**FINDINGS AND RECOMMENDATION
OFFICE OF PLANNING AND ZONING
ANNE ARUNDEL COUNTY, MARYLAND**

CASE NUMBER: 2024-0103-V

REQUEST

The applicant is requesting a variance to allow a dwelling addition with less setbacks than required on property located at 637 Cresswell Road in Brooklyn.

637 Cresswell Road

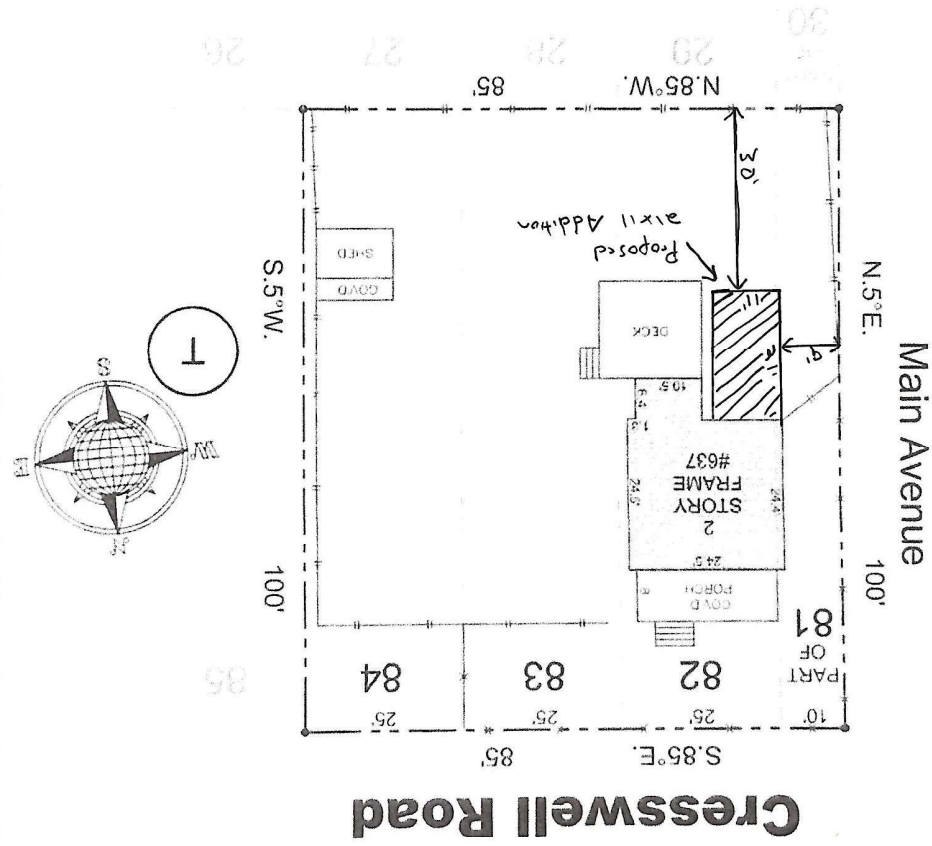
¹ The site plan does not show the existing shed, concrete pad or the above-ground pool, but they can be seen on the 2024 aerial photo. The pool is in the location of a prior pool, but the current pool is larger. A permit has not been found for the increased size pool.

The applicants only say that this addition will provide additional space for a growing family and they do not give information as to how this addition fits into the existing floor plan. According to the site plan submitted, there might appear to be room on the property to construct an addition on the east side of the dwelling. Given that the aerial photo shows an existing pool in that location the proposed location is likely the only practical location for an addition. The variance as requested is considered to be the minimum variance necessary to allow reasonable use of the site.
